# SERVICE BULLETIN

TEIJIN SEIKI CO., LTD.  
GIFU PLANT,

NO. TS-SB-72      DATE 1-10-84  
REV                      DATE  
                            REASON

Phase 1 : Inspection of FIF40000 Fuel Strainer, for prevention of fuel-blockade.

Fig.-1

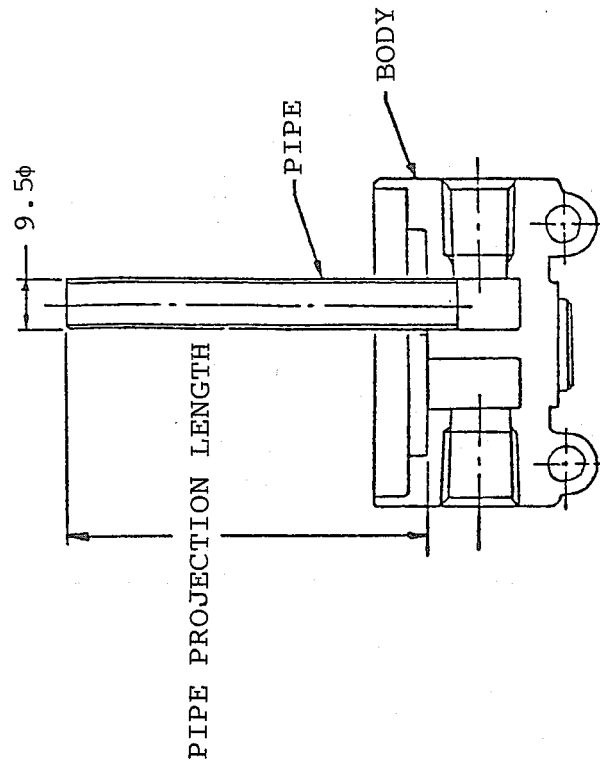
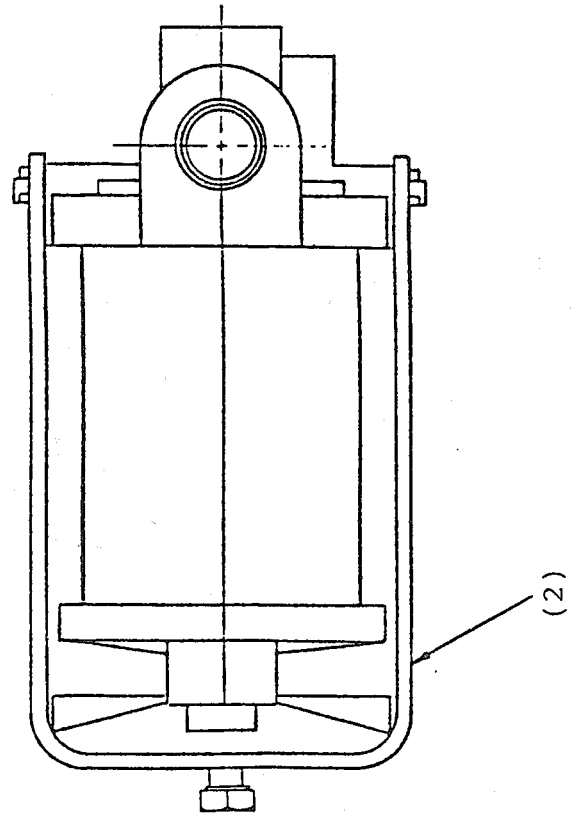
Phase 1 : All strainers defined in paragraph 2 Phase 1 shall be inspected and determined by configuration whether repair work is required according to Fig-1.

Condition; loose pipe and/or pipe which projects less than 62mm from the surface of the body.

- 1) Remove and discard lockwire from bolt (1).
- 2) Untighten bolt (1), tilt bracket (2) and remove cover (3), packings (4) (10), barrel (5), washer (6) and screen (7).
- 3) Check pipe and body as is in assembled condition, according to Fig.-1, to see if repair work is required by its configuration.
- 4) For pipe and body which have been determined to be repaired, further inspection shall be conducted as follows.
  - a. Check the interference fit area of pipe and body for looseness by pulling and pushing the pipe.

NOTE: Pull and push force shall be approximately 50g and no extreme force shall be applied.
  - b. Measure and record the pipe projection length.  
(See Fig.-1)

All Fuel Strainers, requiring repair as a result of above inspection, shall be repaired per Phase 2 procedure within next 25 flight hours, except Fuel Strainer which exhibits condition described below shall be repaired before next flight.

- 5) If the pipe is loose (moving up and down by above pulling and pushing procedure), and/or the pipe projection length is less than 62mm, Phase 2 repair work shall be accomplished before next flight.  
If there is not evidence of any of above condition, the strainer may be reassembled as per paragraph 7) and 8) for additional flight usage, but shall be

Fig.-2 STRAINER ASSEMBLY (before repair)

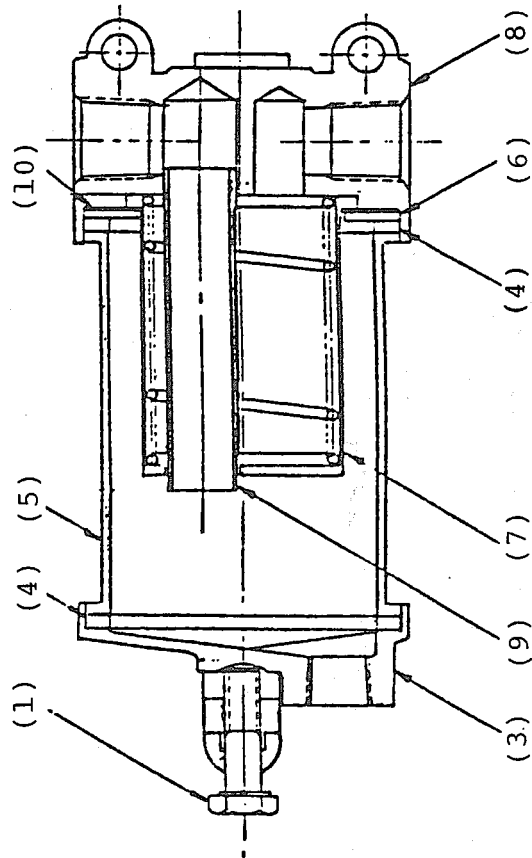
12. Detailed Instruction (Reference : Fig-2)

- 1) Remove and discard lockwire from bolt (1).
- 2) Untighten bolt (1), tilt bracket (2) and remove cover (3), packings (4) (10), barrel (5), washer (6) and screen (7).
- 3) Pull out pipe (9) from body (8).
- 4) Check and clean the hole in the body (8) and insert the replacement pipe (P/N FIF40020) into the hole by pressing or by tapping it with a plastic hammer, until a shoulder on the pipe comes in contact with the surface of body (8).  
Clean the parts. (Reference : Fig.-3)
- 5) Clean and reassemble the parts that have been removed in paragraph 2). Tighten bolt (1) to the torque of 15-20 IN.LBS.
- 6) Apply lockwire on bolt (1).

Phase 2 : The repair work is to replace the pipe with FIF40020 pipe.
